Artesian 230kV Substation Expansion Project CPUC Minor Project Refinement Form

Date Requested: April 2, 2020

Report No.: MPR-2 (Rev.2)

Figure MPR-2(a):
Bernardo Substation Circuit Breaker Modifications

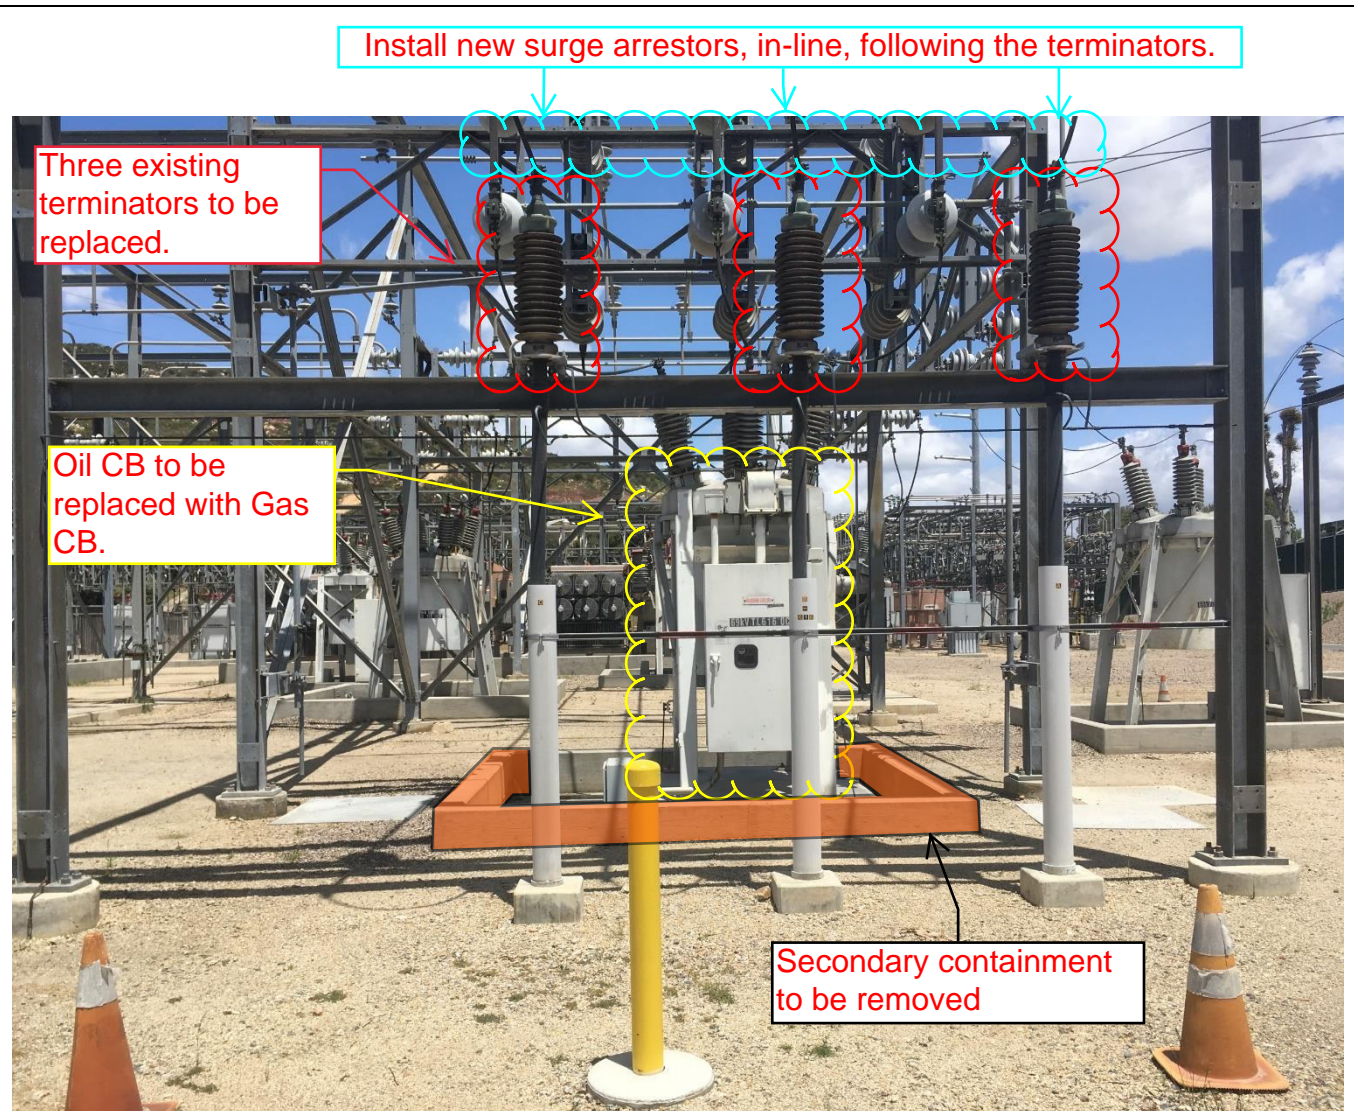
- At the Bernardo Substation:
 - Replace an existing oil circuit breaker (CB) with a new gas CB (see Photograph No. 1 below and Figure MPR- 2(a) – Bernardo Substation Circuit Breaker Modifications in Attachment A). The gas CB will utilize sulfur hexafluoride (SF_6), the same as the new CBs being installed at the Artesian Substation.

- Remove the secondary containment structure for the existing CB; however, the foundation will remain in place. Refer to Figure MPR-2(a) in Attachment A.

- Install a new surge arrester for the new gas CB. Refer to Figure MPR-2(a) in Attachment A.
 - Replace the existing terminators for the new gas CB. Refer to Figure MPR-2(a) in Attachment A.

The additional minor modifications inside the existing Bernardo and Rancho Carmel Substations are required to facilitate the connections to the new 69kV underground getaways and power line reconductors. The secondary containment structure at the Bernardo Substation will be removed because it is not needed for the gas CB. The existing CB foundations will remain in place and be utilized for the new CBs.
